Subject: Addendum to Revised Pore Water and Seepage Study Work Plan
PG&E Topock Compressor Station, Needles, California

8.1 Contingency Plan

FIGURE 8-1

PORE WATER AND SEEPAGE STUDY WORK PLAN
PG&E TOPOCK COMPRESSOR STATION
NEEDLES, CALIFORNIA

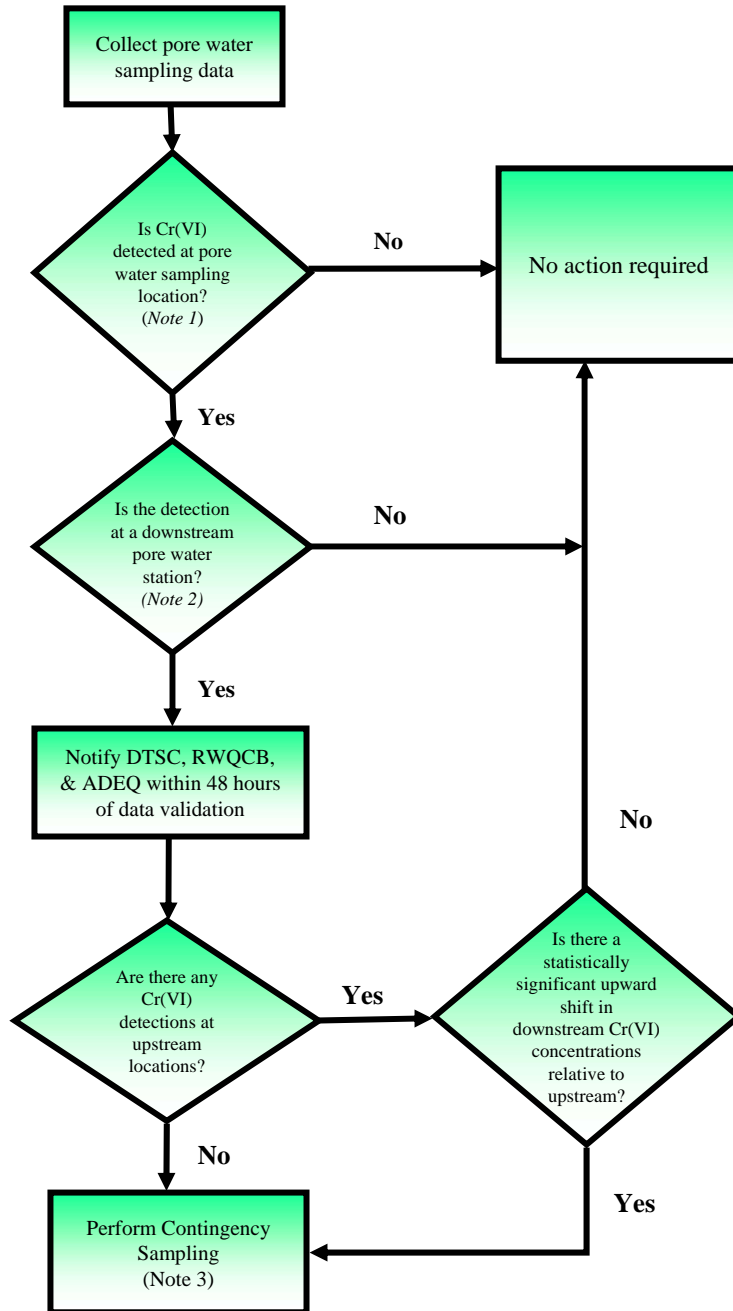
Enclosed is an addendum to the *Revised Pore Water and Seepage Study Work Plan* for the Pacific Gas and Electric Company (PG&E) Topock Compressor Station. The addendum is a revision to Section 8.1 of the work plan, contingency plan for responding to the pore water sampling results. The contingency plan reflects revisions described in condition 4 in the Department of Toxic Substances Control comment letter dated November 14, 2005.

In the event that Cr(VI) is detected in pore water in the downgradient sampling locations, the PWSS Contingency Plan will be implemented. Figure 8-1 presents the events that would occur in the event of a Cr(VI) detection in pore water downstream of the Topock site. DTSC, Regional Water Quality Control Board, and Arizona Department of Environmental Quality will be notified of any Cr(VI) detection in pore water at a downgradient sampling location within 48 hours of data validation completion. Any Cr(VI) detection in pore water at a downstream location in the absence of any Cr(VI) detections upstream will trigger resampling to confirm downstream detections and further define the distribution of Cr(VI) in the pore water of the river bottom. If Cr(VI) is detected in pore water at both upstream and downstream locations, the Wilcoxon Rank Sum Test will be performed to determine whether there is a statistically significant upward shift in the downstream concentrations relative to the upstream concentrations, as indicated by a 90% confidence interval for the test ($P < 0.10$ for a one-tailed test). Since many of the results will likely be non-detects, it may be necessary to provide a single proxy value for non-detects. Ordinarily, a proxy value of one-half of the detection limit would be applied; however, if the detection limits vary considerably, the scatter of the proxy values might become more dominant in the calculations than the level of detected values. In this event, a review of the data will be conducted to determine if it would be more appropriate to choose a single proxy value rather than use one-half of the detection limit. The results of the statistical analyses will be reported to DTSC within 14 days of the receipt of all the validated data from the initial pore water sampling.

Pore water resampling will be performed if Cr(VI) is detected at a downstream location in the absence of any Cr(VI) detections upstream or if Cr(VI) concentrations at downstream locations are demonstrated to be statistically significantly greater than upstream concentrations. The contingency sampling would involve:

- Re-sampling pore water at location(s) where there was a significant Cr(VI) detection.
- Sampling pore water 20 feet from the location of the significant detection in four directions. Samples will be collected at the depth of the original detection.
- Collecting a surface water sample above the pore water detection to determine if Cr(VI) is present in the river channel. Surface water samples will be collected in accordance with the *Revised Sampling Plan and Standard Operating Procedure for Depth-Specific Surface Water Sampling* (CH2M HILL 2005f).
